**Transmission Access Reform Interim Report  
Updated Technical Specifications and Cost-Benefit Analysis  
Reference: ERP0073**

The Australian Energy Council (the “AEC”) welcomes the opportunity to make a submission in response to the Australian Energy Market Commission’s (“AEMC’s”) *Transmission Access Reform Interim Report*.

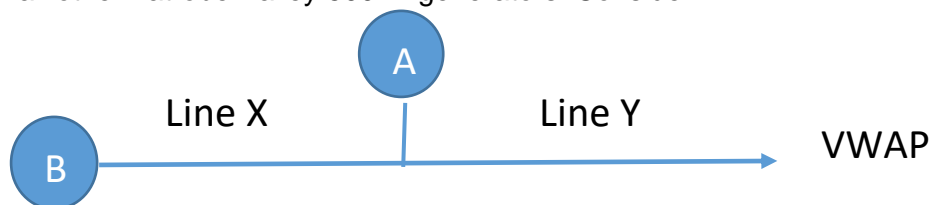
There may be a misunderstanding of how the simultaneous feasibility mechanism within the FTR auction operates. The mechanism is able to translate access from any connection point to any other to the extent that the network physically permits it. For example, with the full nodal approach, if one Latrobe Valley 500kV generator bids for an FTR instrument at its connection point, it will be competing with all other Latrobe Valley 500kV generators. Consider:

The "hub" approach would see both generators only able to access FTRs from point A, leaving a basis risk for generator B associated with Line X's capacity.

However, the simultaneous feasibility auction incorporates a full network model and is able to contemplate the capacities of both lines X and Y. The nodal approach would see both generators, even though they are bidding for their respective connection points, competing for access to the capacity to Line Y. However, if generator B is successful, its FTR would also cover potential congestion on Line X.

If, subsequently, generator B chooses to sell its FTRs back into the auction, the simultaneous feasibility assessment would identify that access to Line Y is now available, and generator A could buy at least as many MW as generator B had released.

Thus the full nodal approach can achieve the same liquidity and competition than the hub approach: the limitation being only the physical capacity of the network.
